DATE: January 16, 2020

FROM: Wight & Company
2500 N. Frontage Road
Darien, IL 60561

SUBJECT: **ADDENDUM #3 TO THE BIDDING DOCUMENTS FOR:
NORTH HIGH SCHOOL BID GROUP #10
MASTER FACILITY PLAN IMPLEMENTATION
COMMUNITY HIGH SCHOOL DISTRICT 99
NORTH HIGH SCHOOL
4436 MAIN STREET
DOWNERS GROVE, IL 60516**

S3.4c

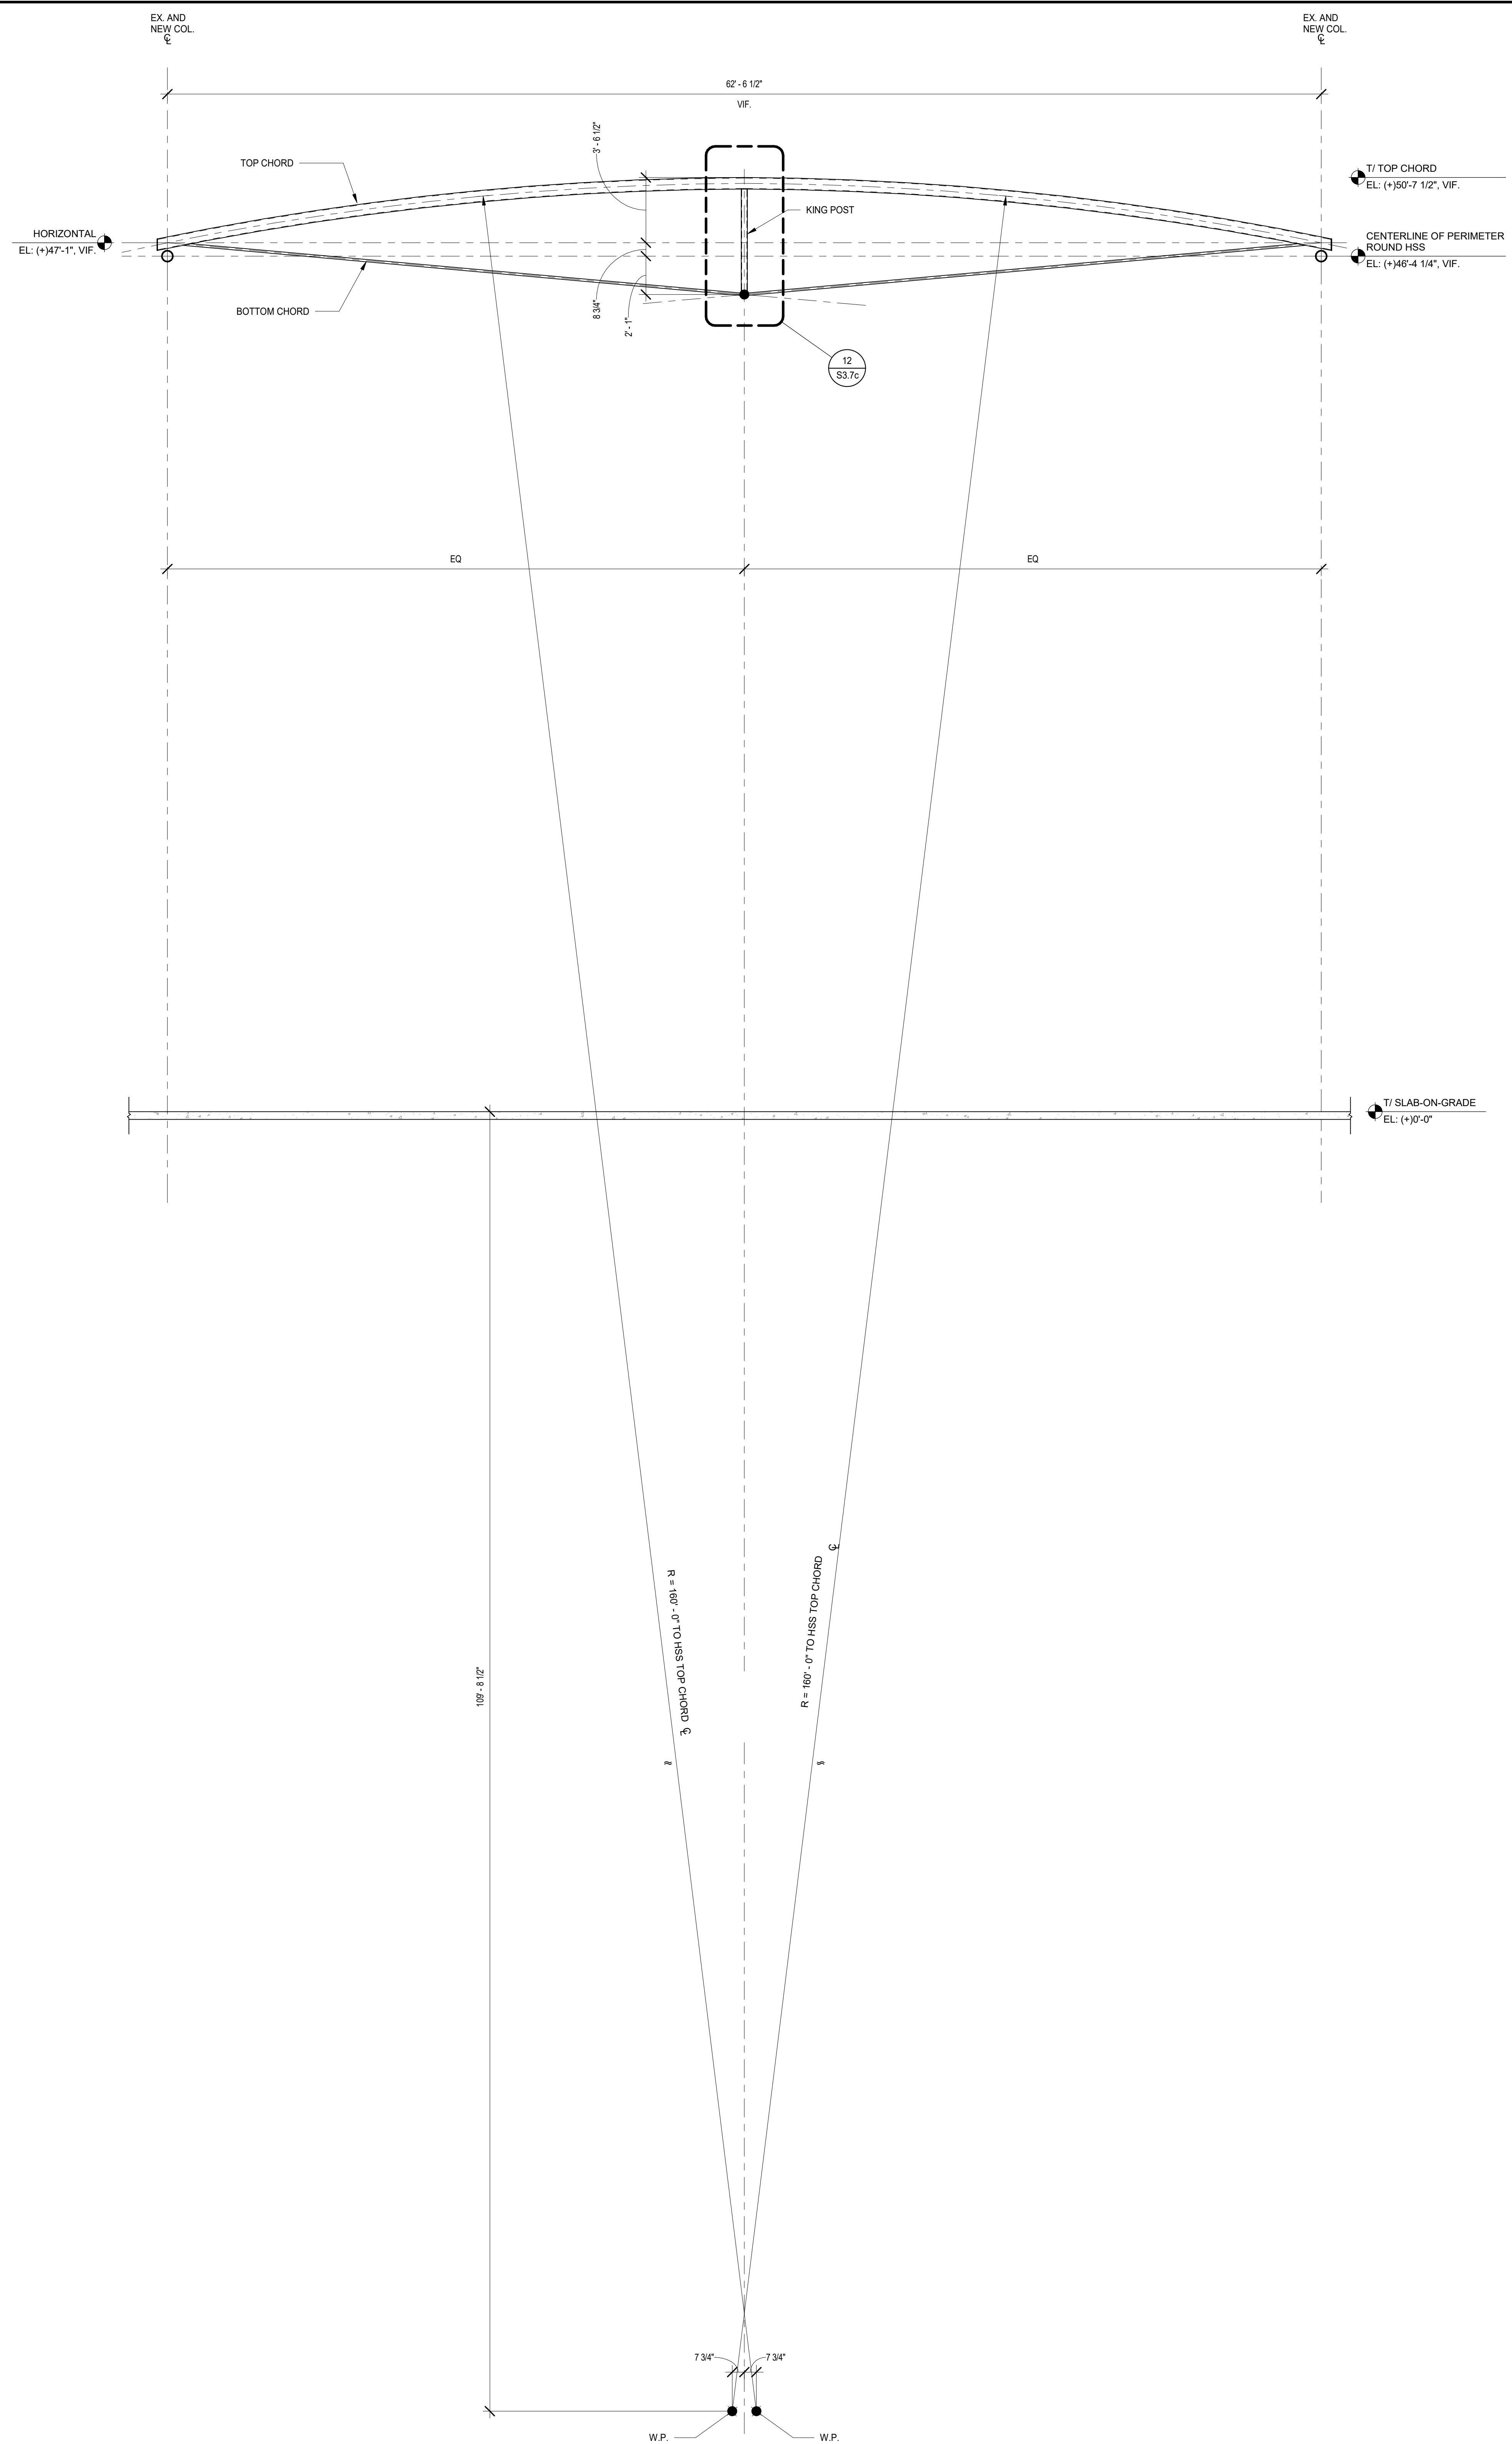
- Added note to detail 4

21 FRAMING DETAIL
SCALE: 3/4" = 1'-0"

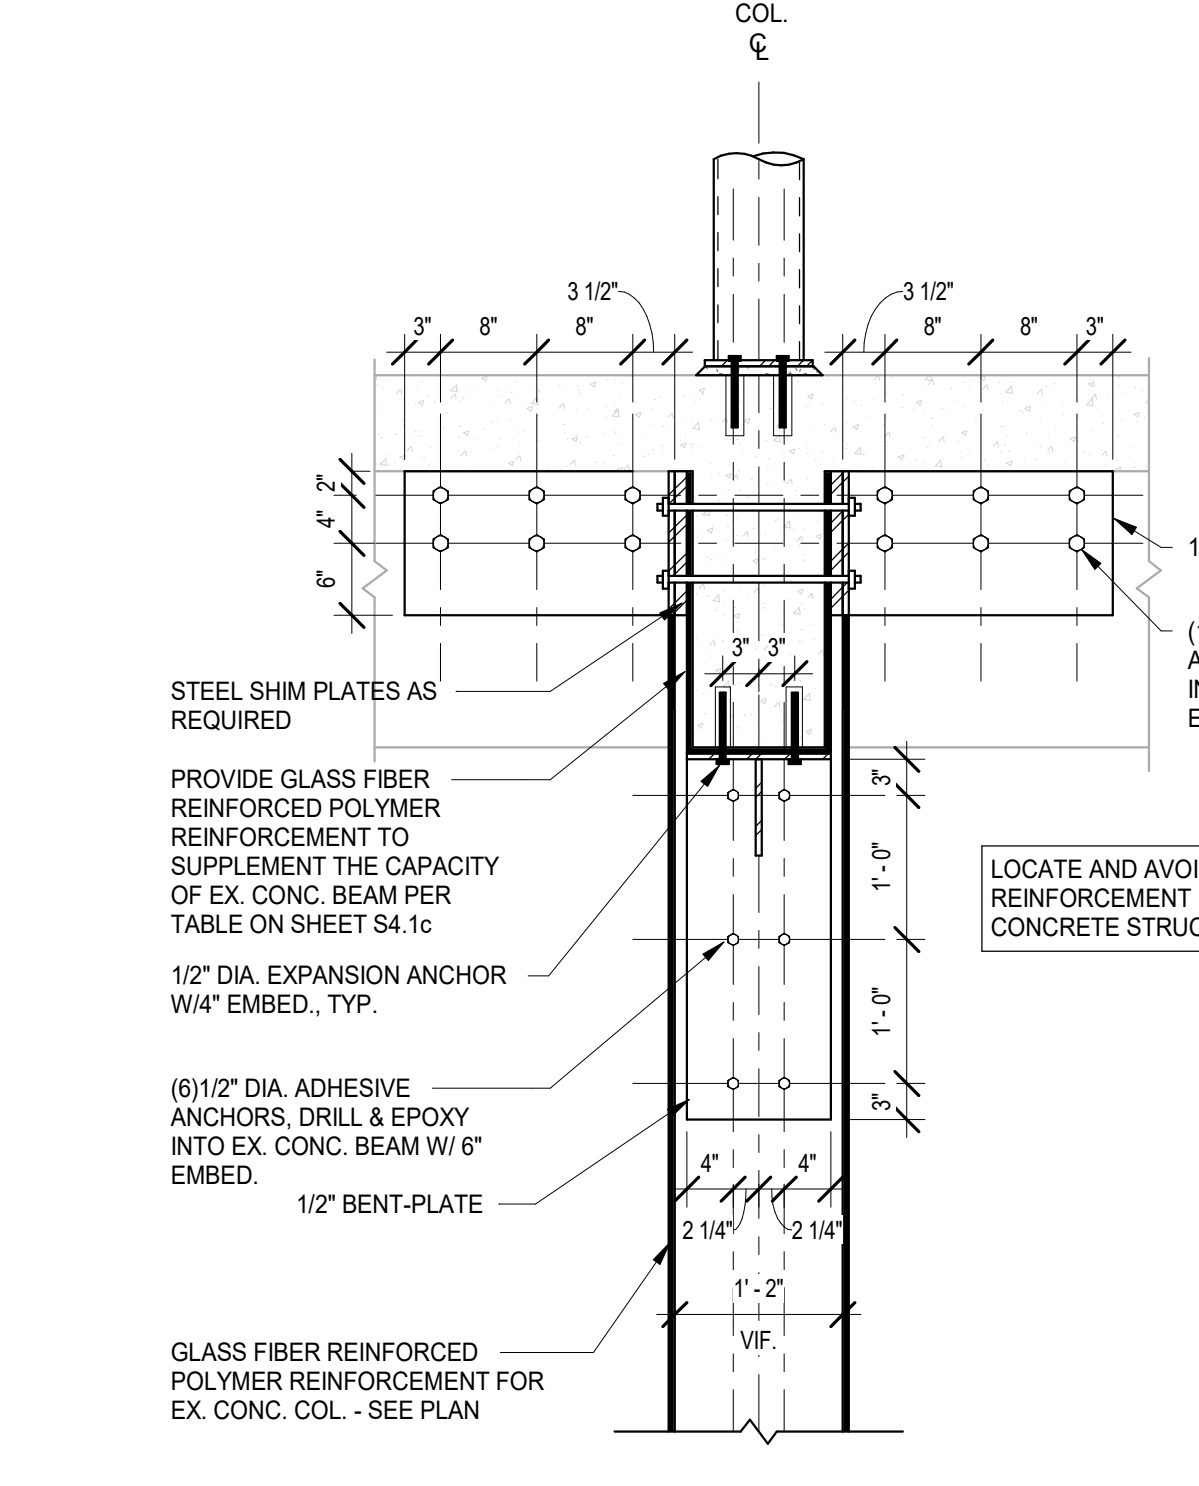
- Revised detail 21

6 SECTION DETAIL - 1928 ENTRY
SCALE: 1" = 1'-0"

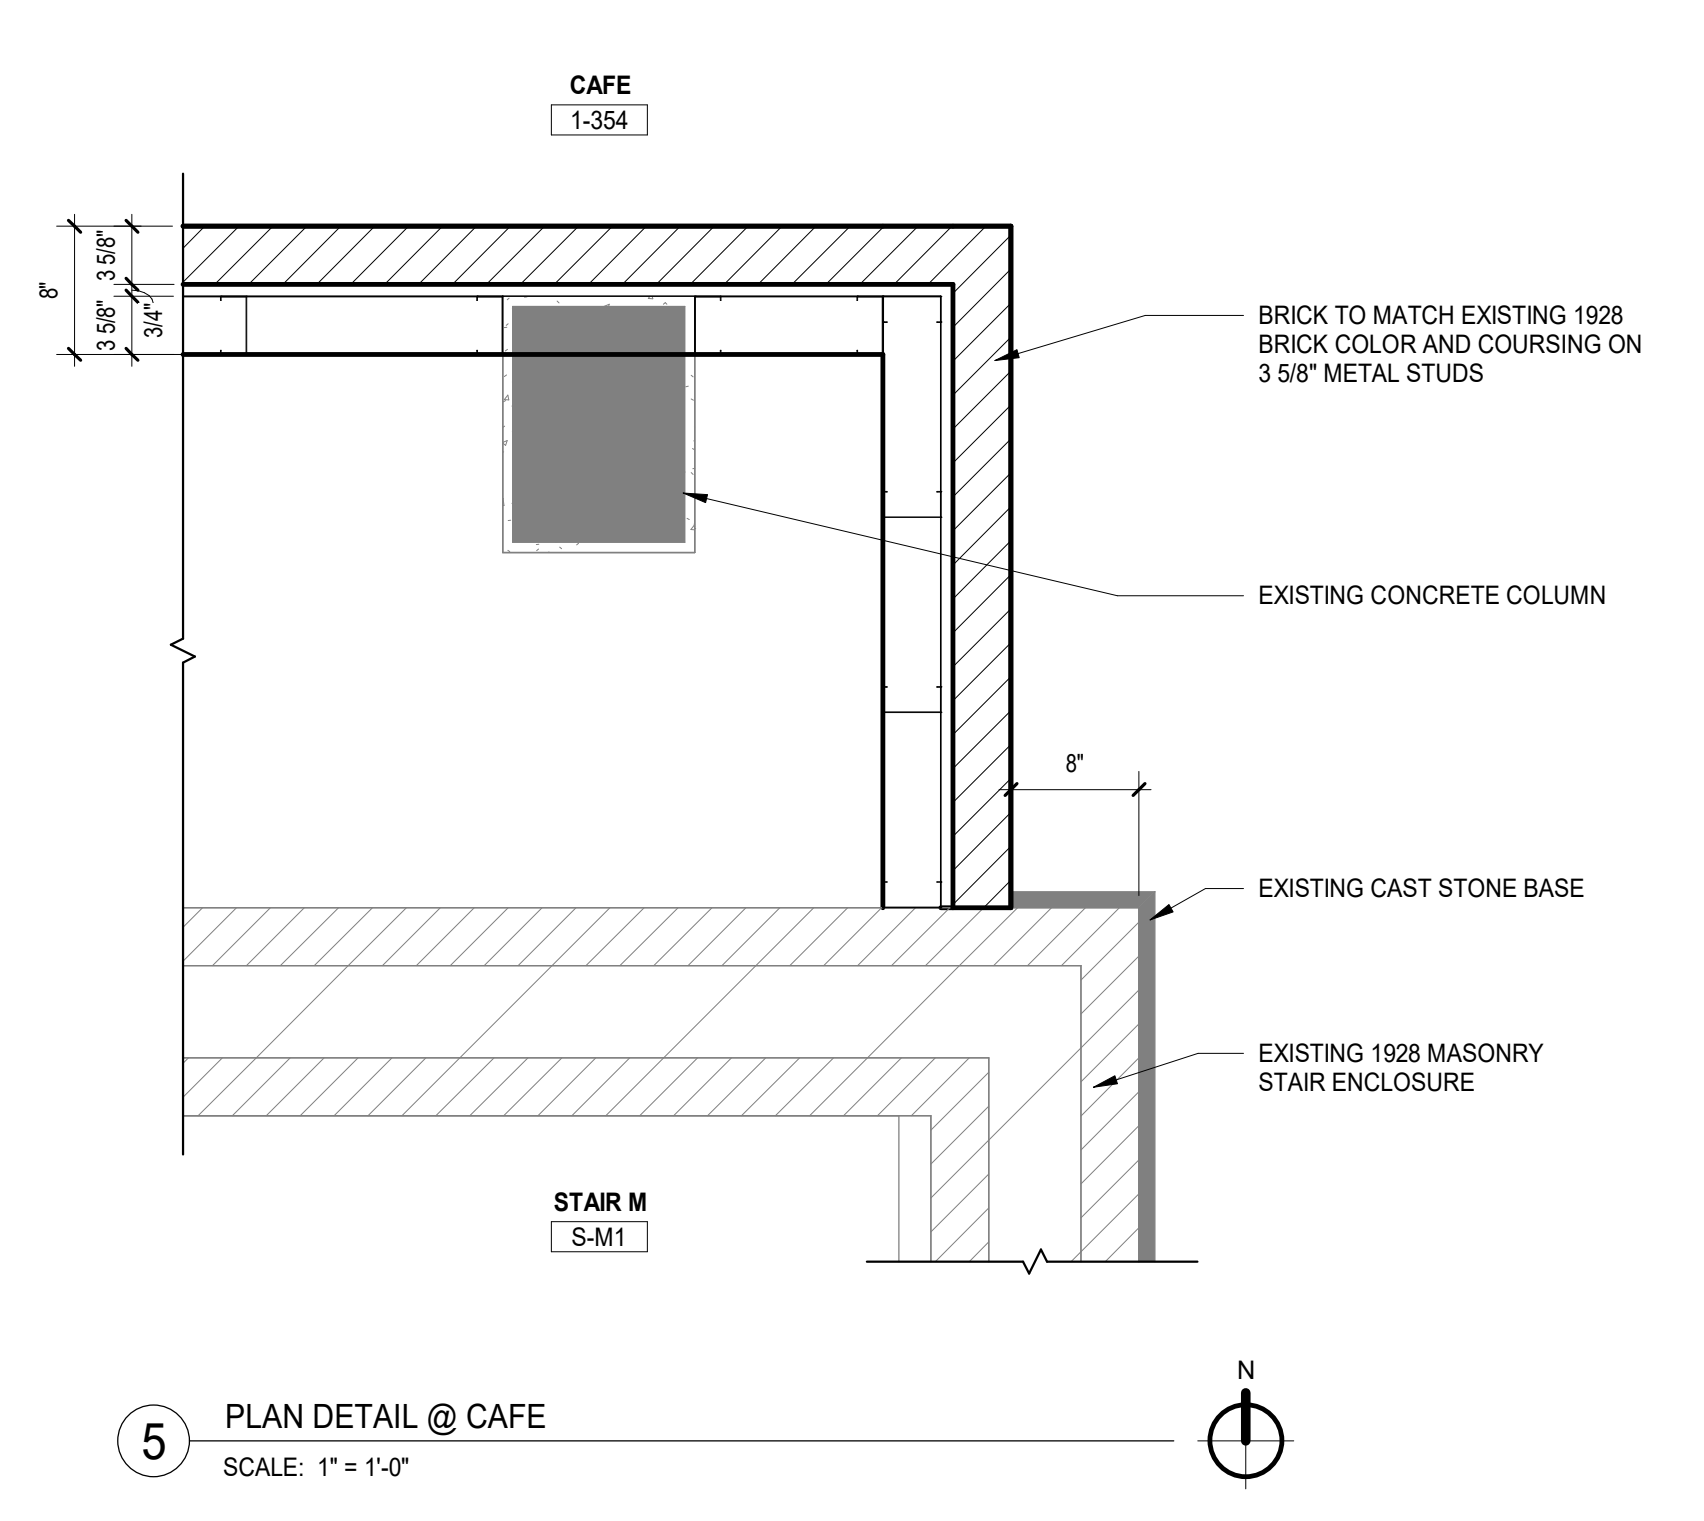
18.	Please provide clarification on who is going to be responsible for the engineering stamp and qualification the CFMF will handle the cast stone load on Detail 6 on A2.30. Also, even after something is designed there is no possible annex point to install the cast stone in two pieces. The access on the south end is only 12" to reach in and attach the cast stone. Please provide some clarification on how to anchor the cast stone sufficiently to avoid possible release and injury.	1-3-20	The detail has changed in Addendum #3 to thin set stone tile on tile backer board.	1-14-20 DS
